155-056-10

## **ADDENDUM NO. 1**

Nebraska Administrative Services - 1526 Building Remodel  
Lincoln, NE  
TCEP Project No.: 156-056-10

Addendum #01  
Supplemental Drawing: SDA-001  
Revision of Sheet: G0.0  
Date: March 23, 2012

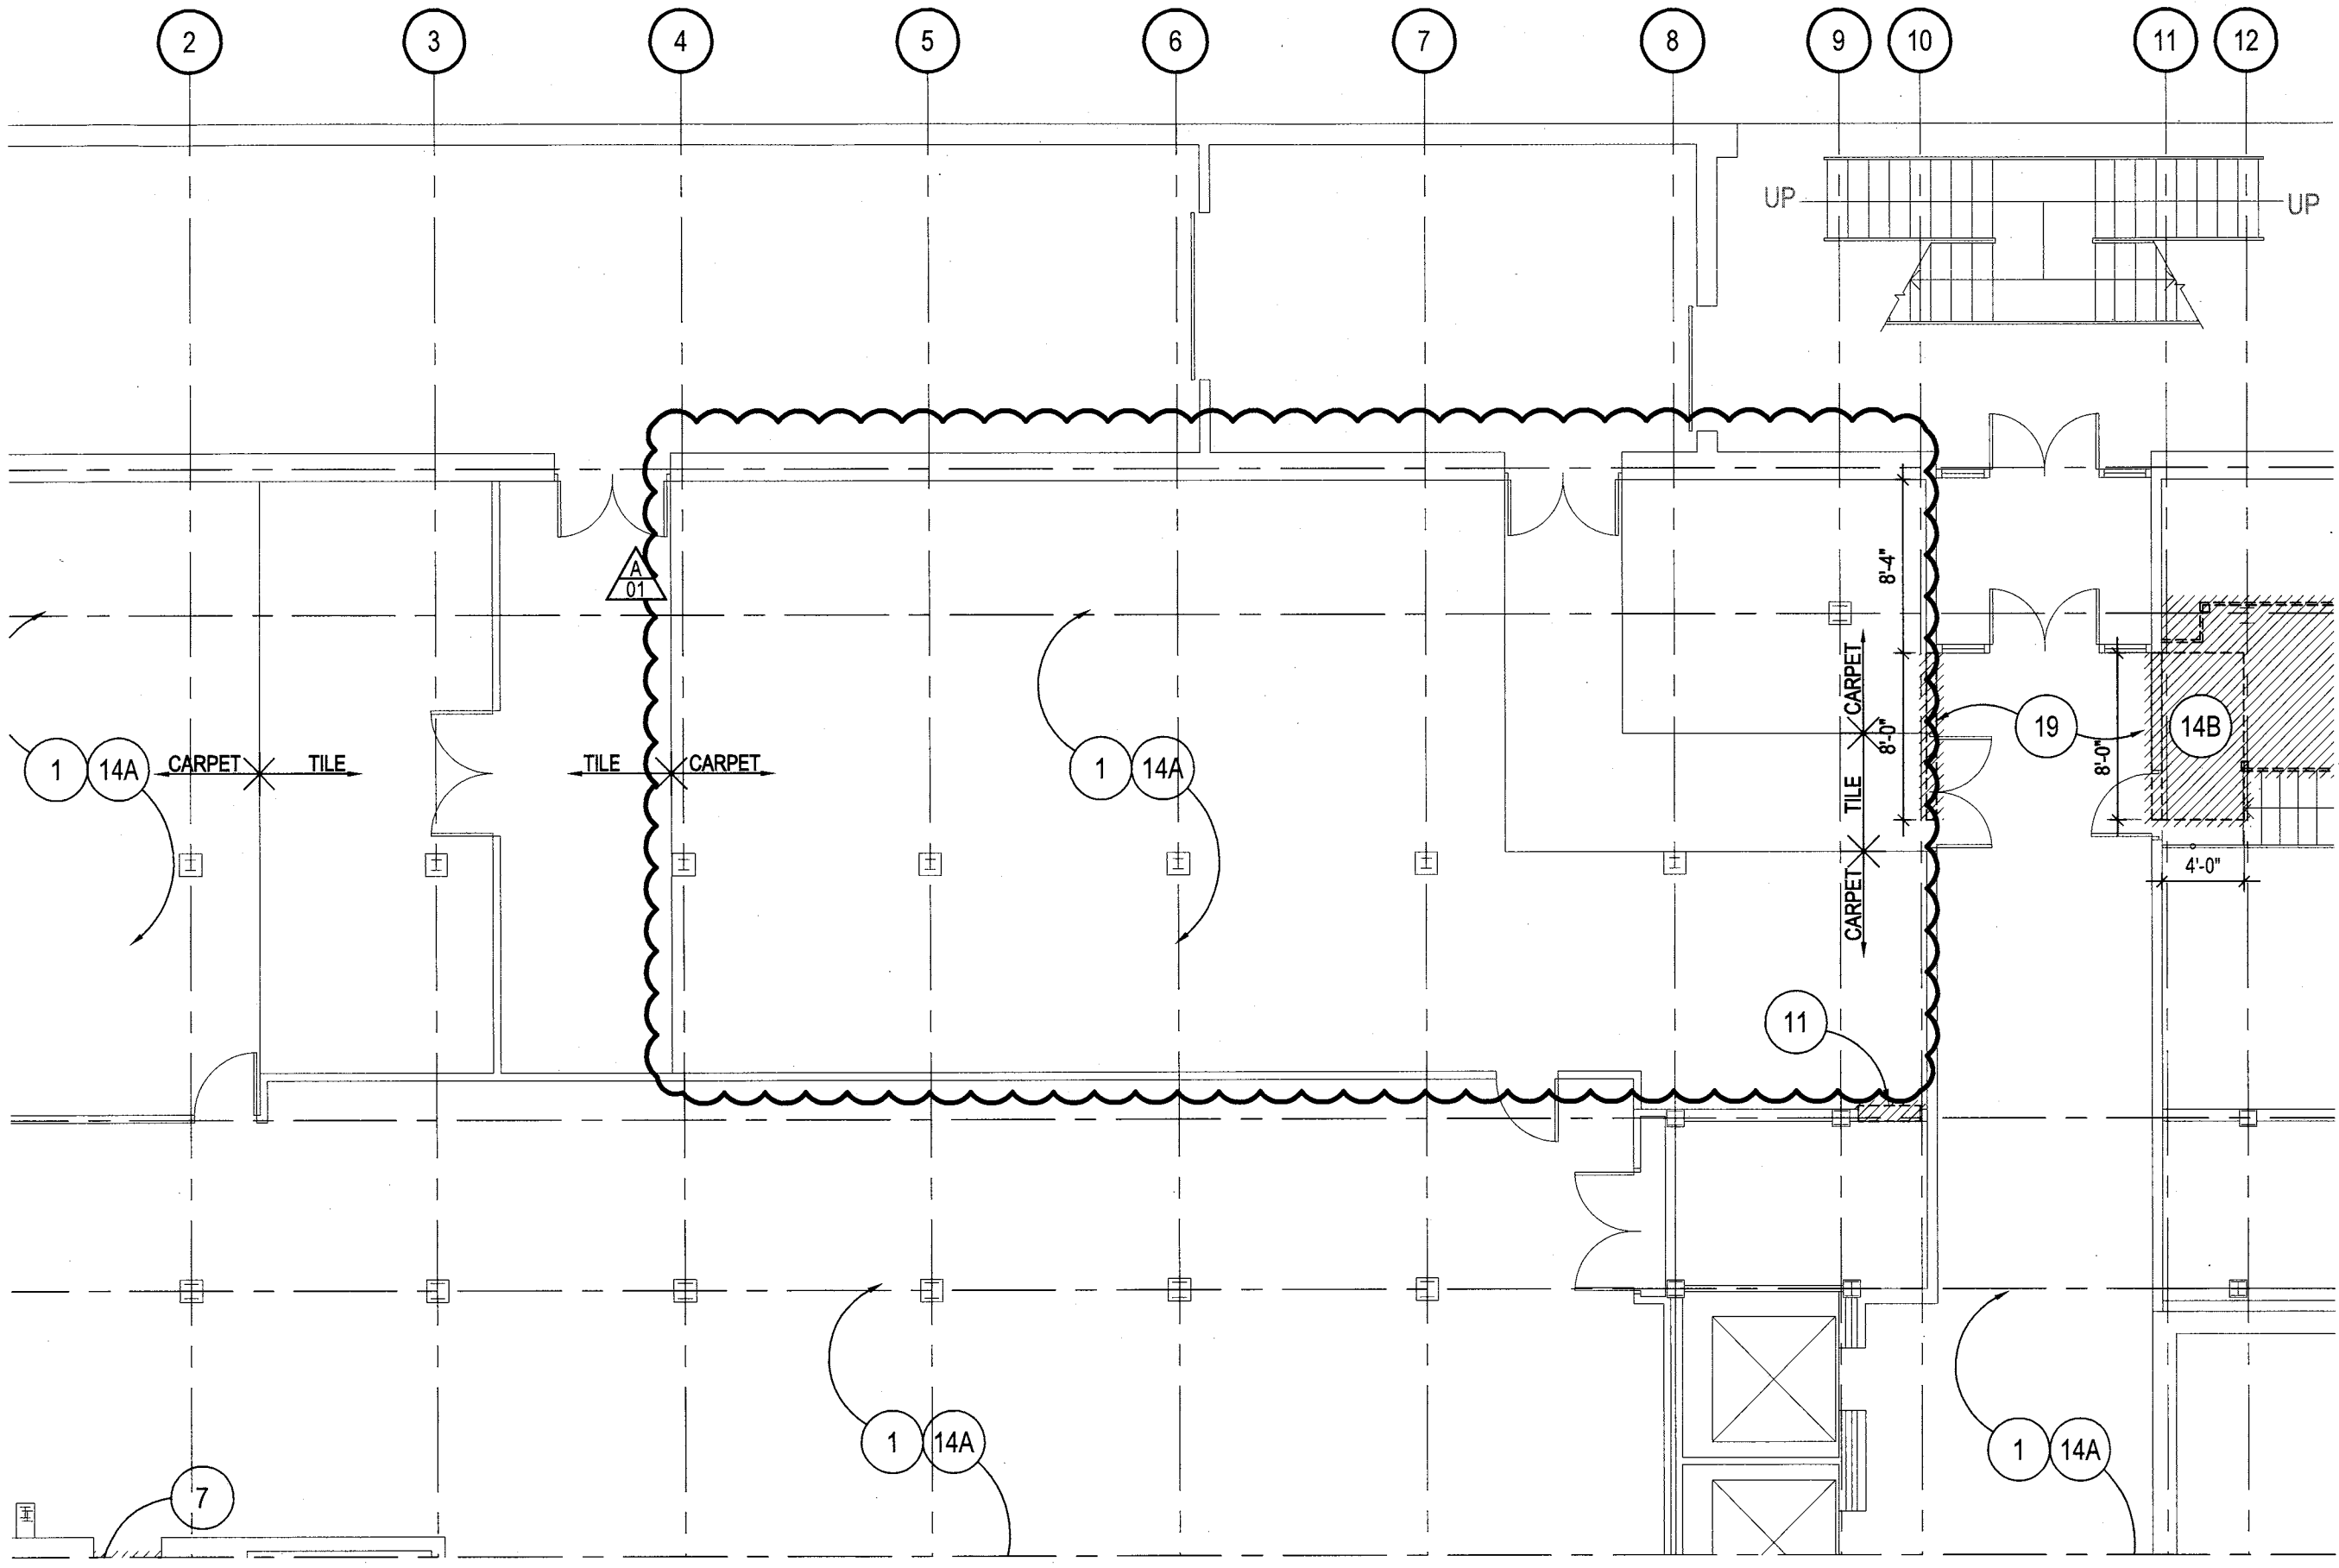
Refer to attached supplemental drawing SDA-001 for changes to List of Alternates.

Addendum #01  
Supplemental Drawing: SDA-002  
Revision of Sheet: A0.0  
Date: March 23, 2012

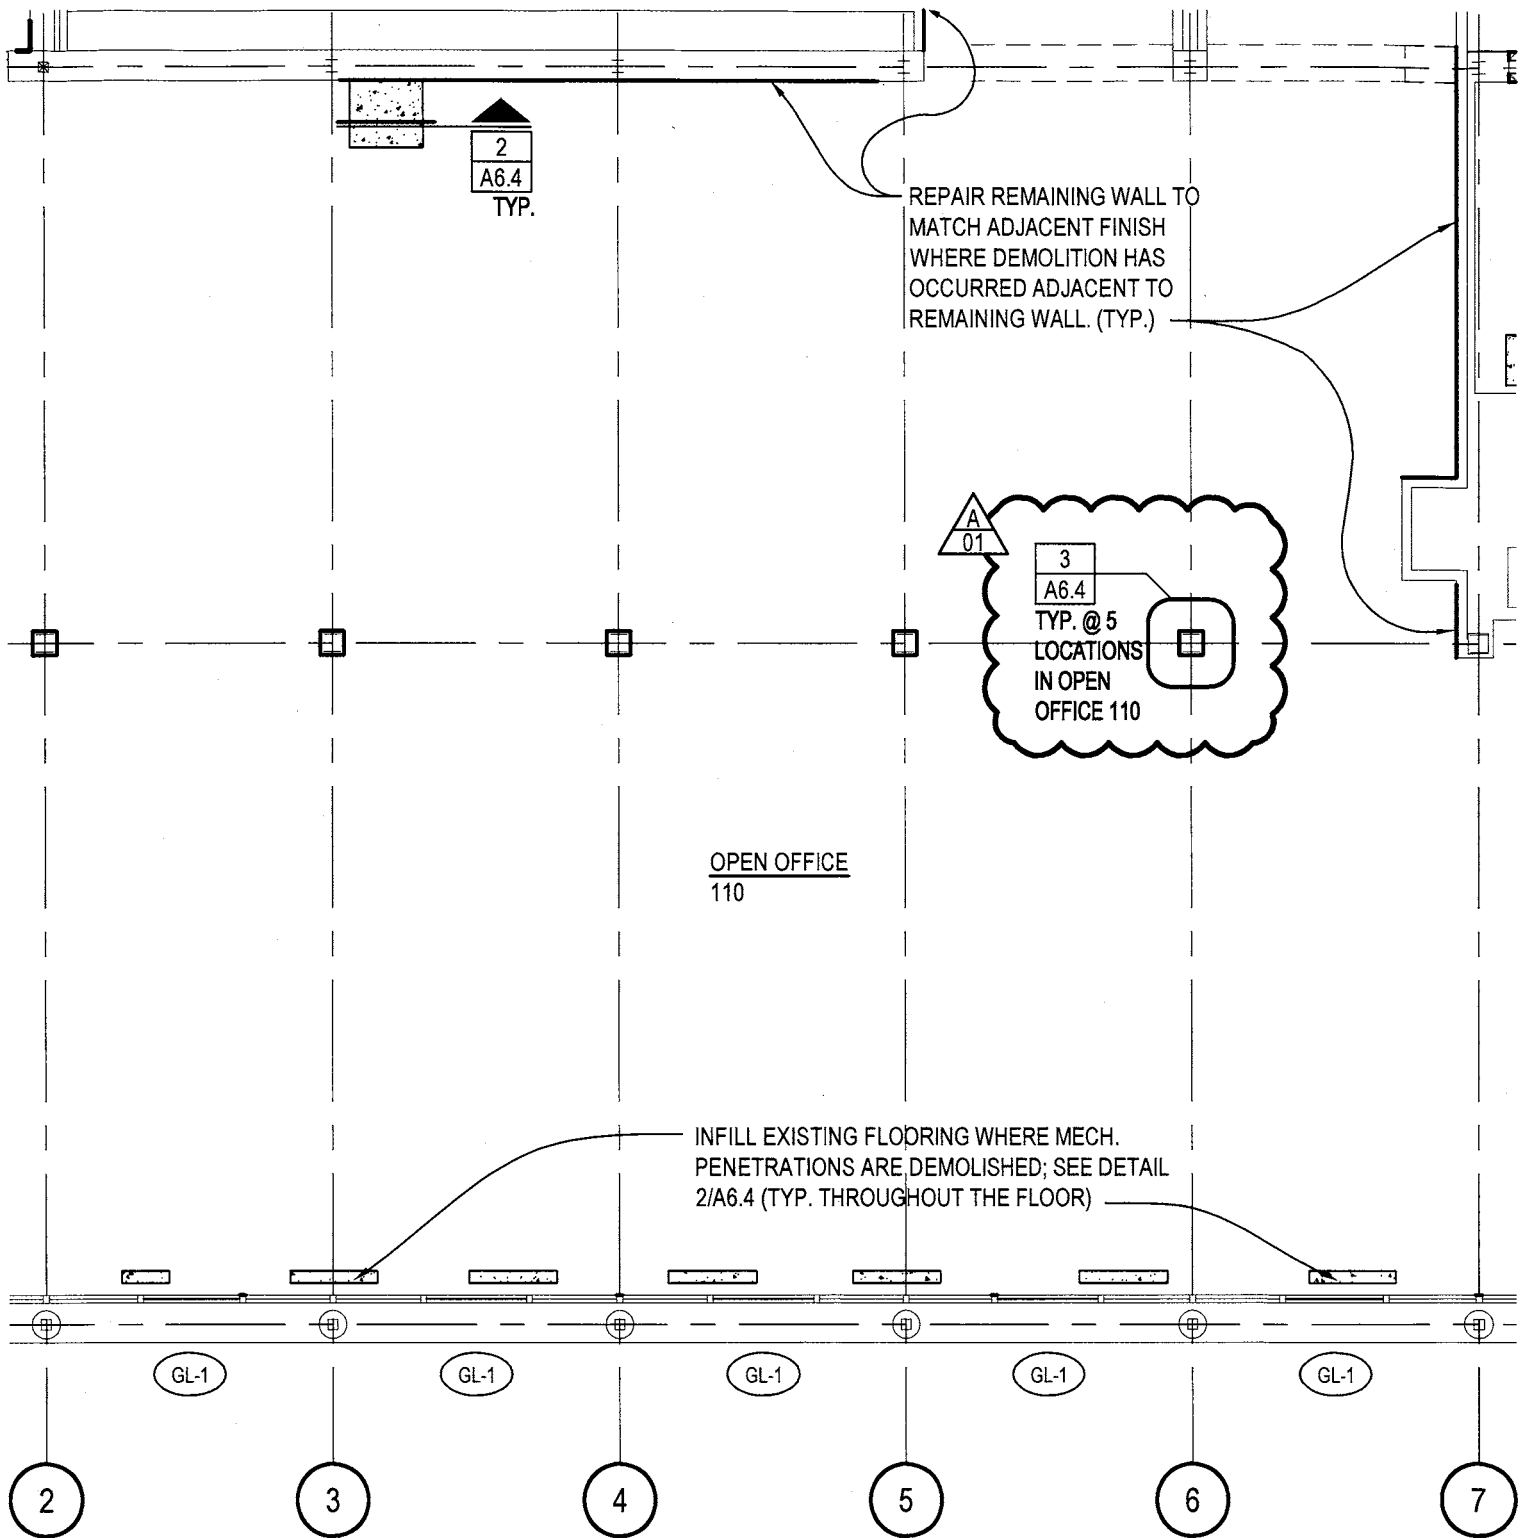
Refer to attached supplemental drawing SDA-002 for changes to drawing. Removed casework demolition from scope of demolition work.

Addendum #01  
Supplemental Drawing: SDA-003  
Revision of Sheet: A1.1  
Date: March 23, 2012

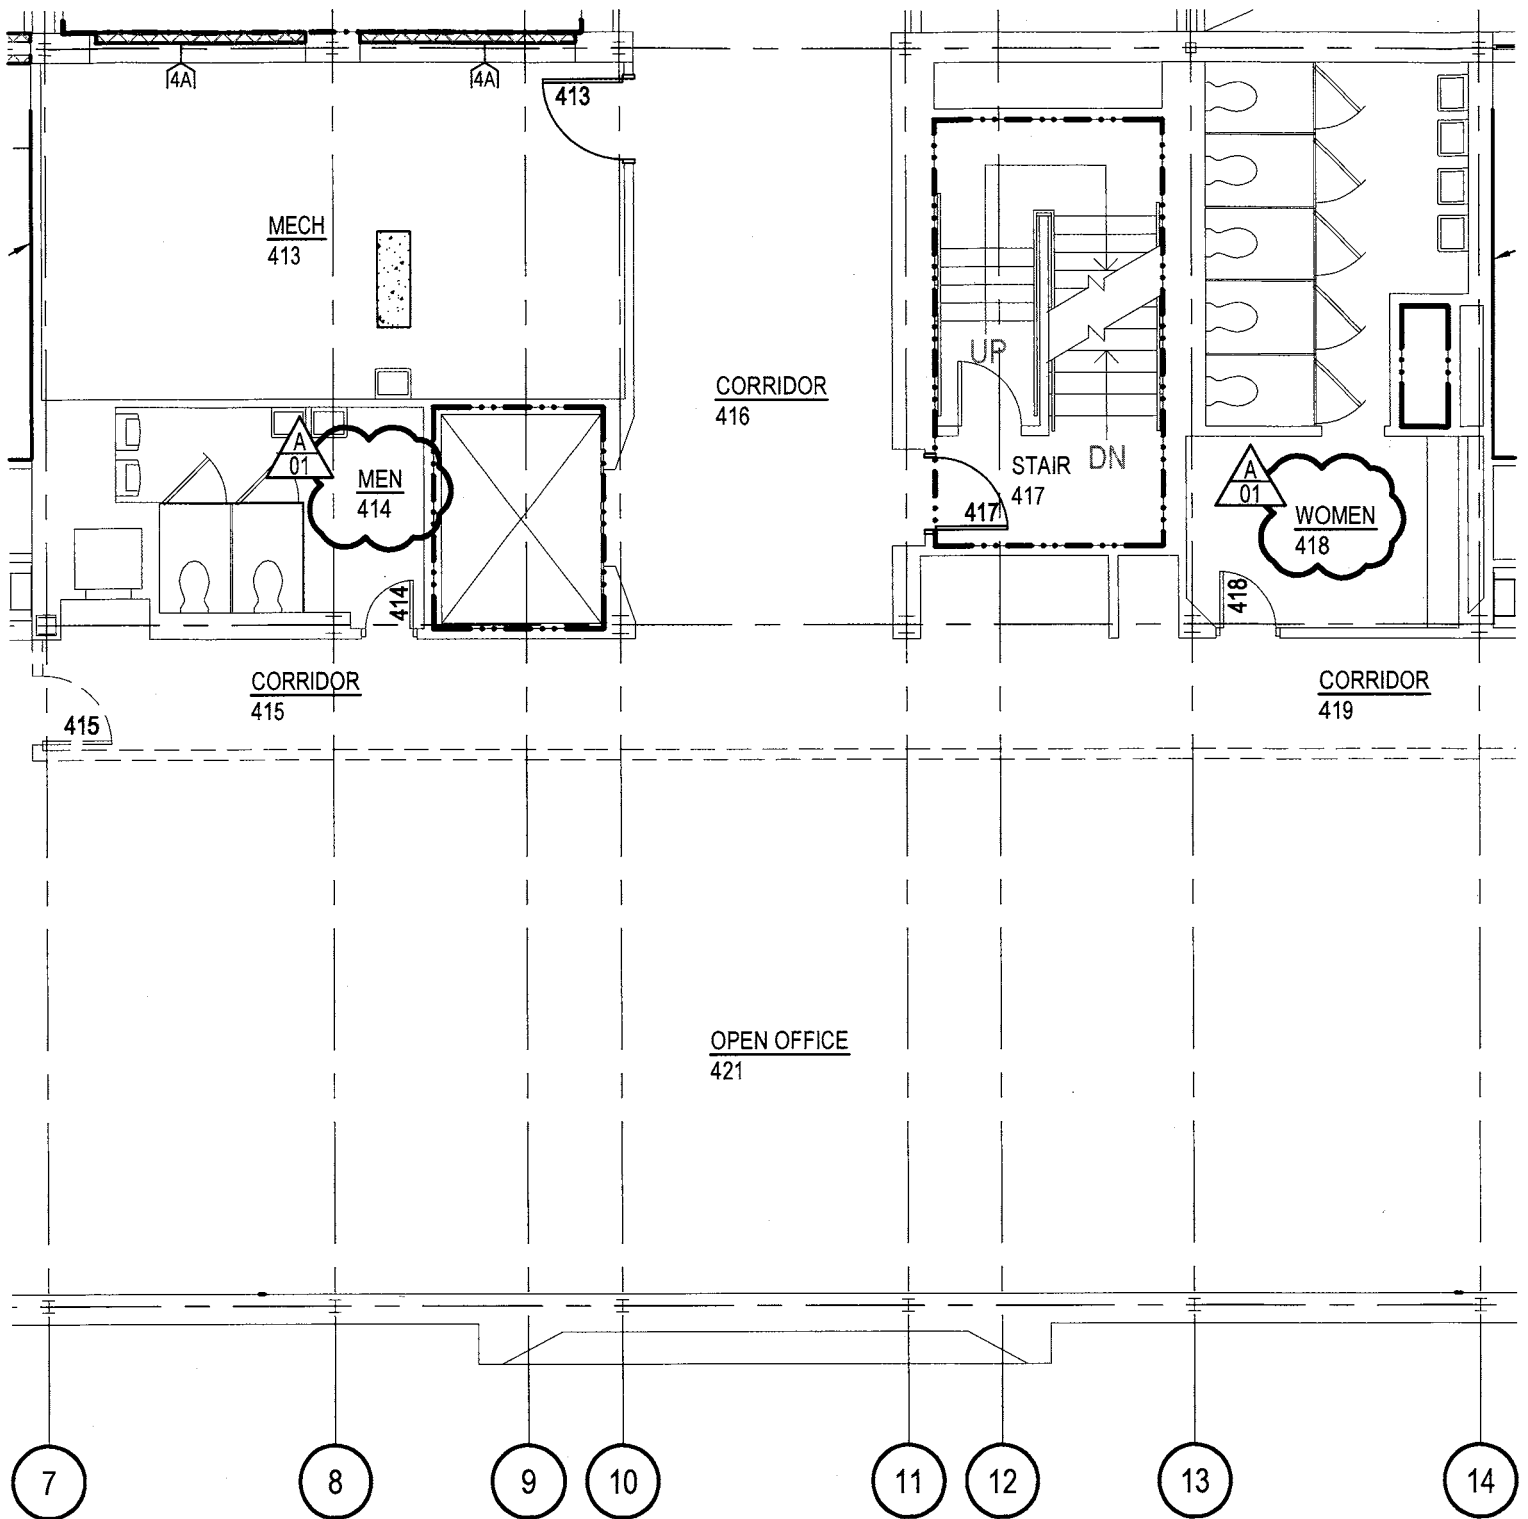
Refer to attached supplemental drawing SDA-003 for changes to drawing. Added note to drawing tag.

Addendum #01  
 Supplemental Drawing: SDA-004  
 Revision of Sheet: A1.4  
 Date: March 23, 2012

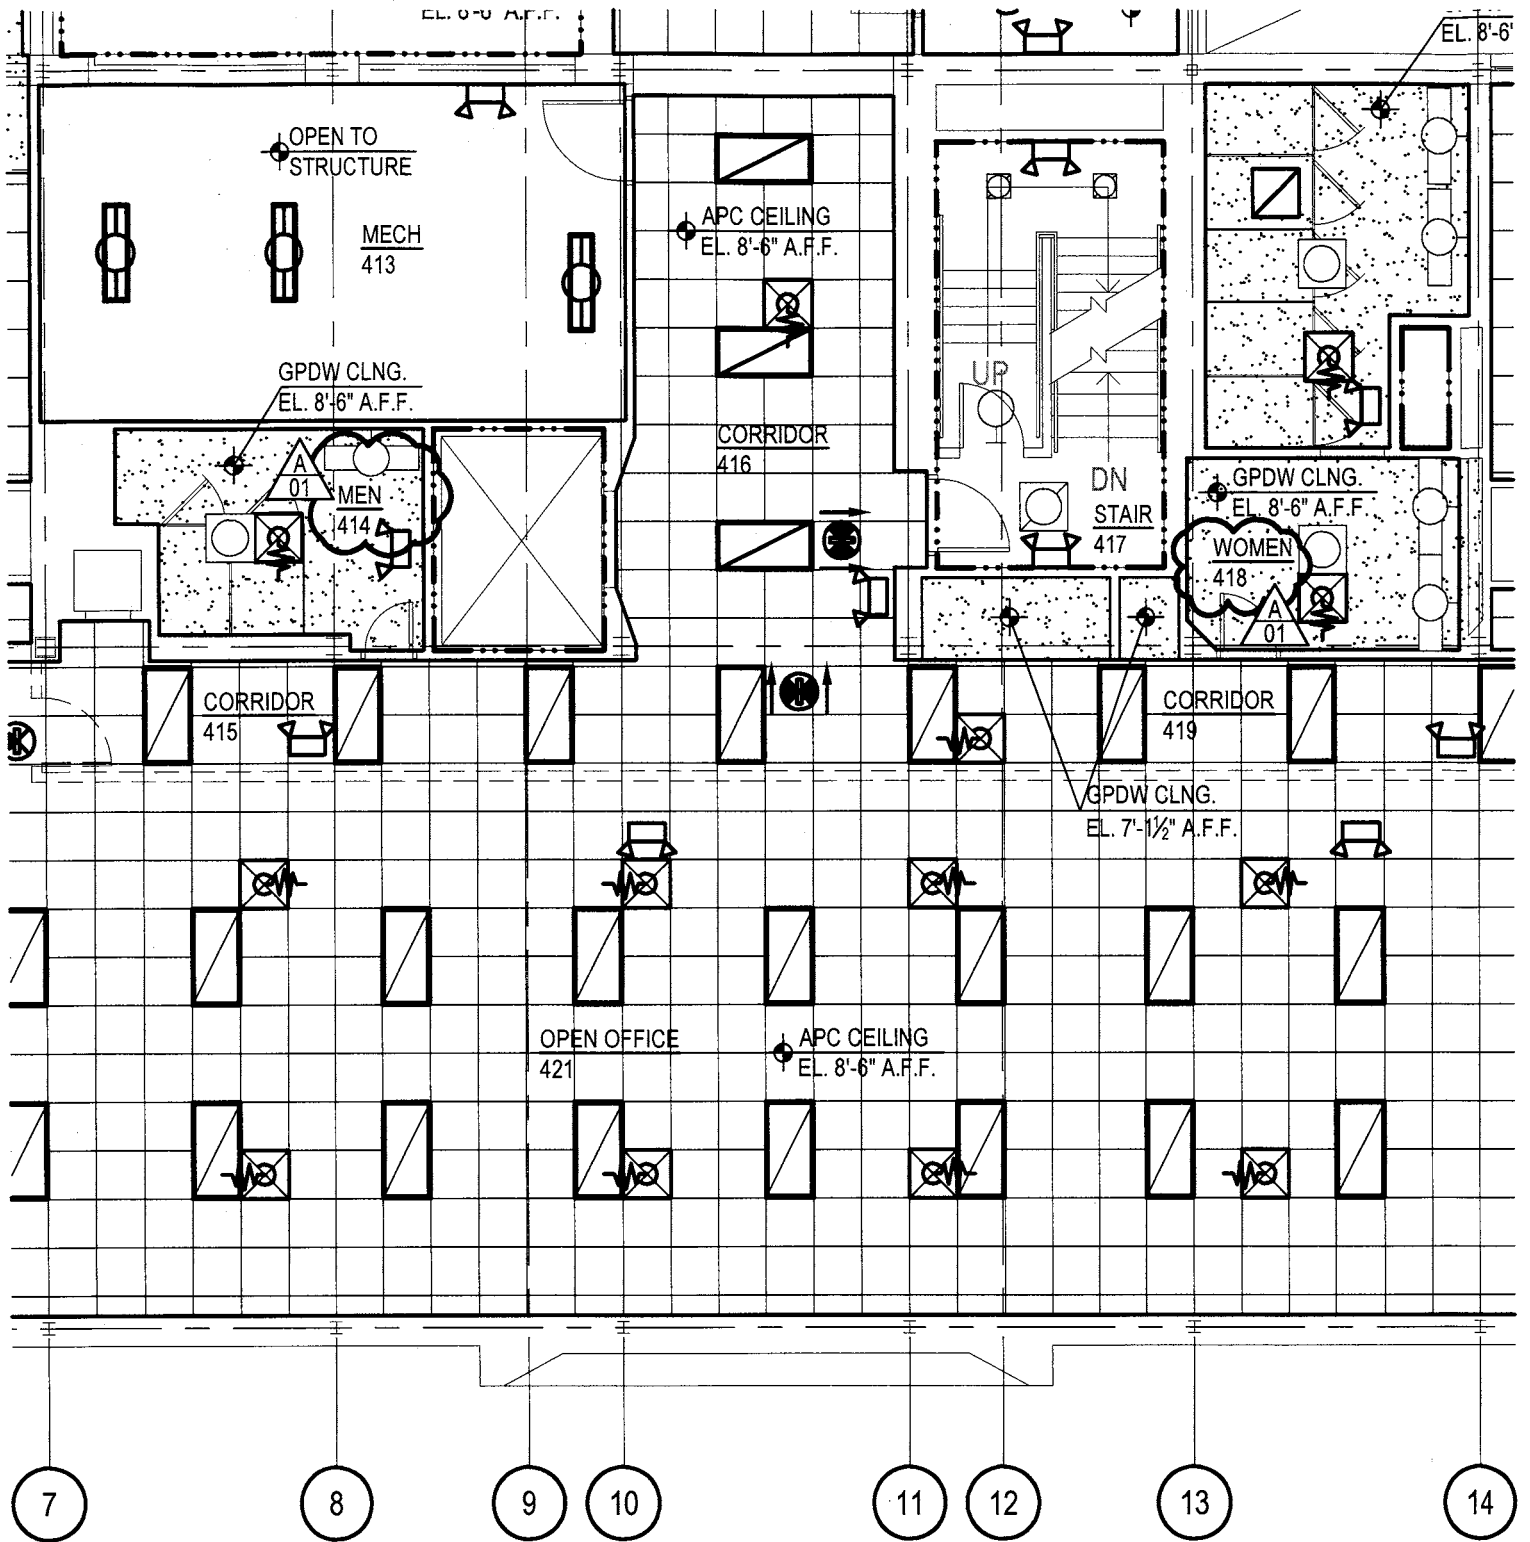
Refer to attached supplemental drawing SDA-004 for changes to drawing. Changed room names.
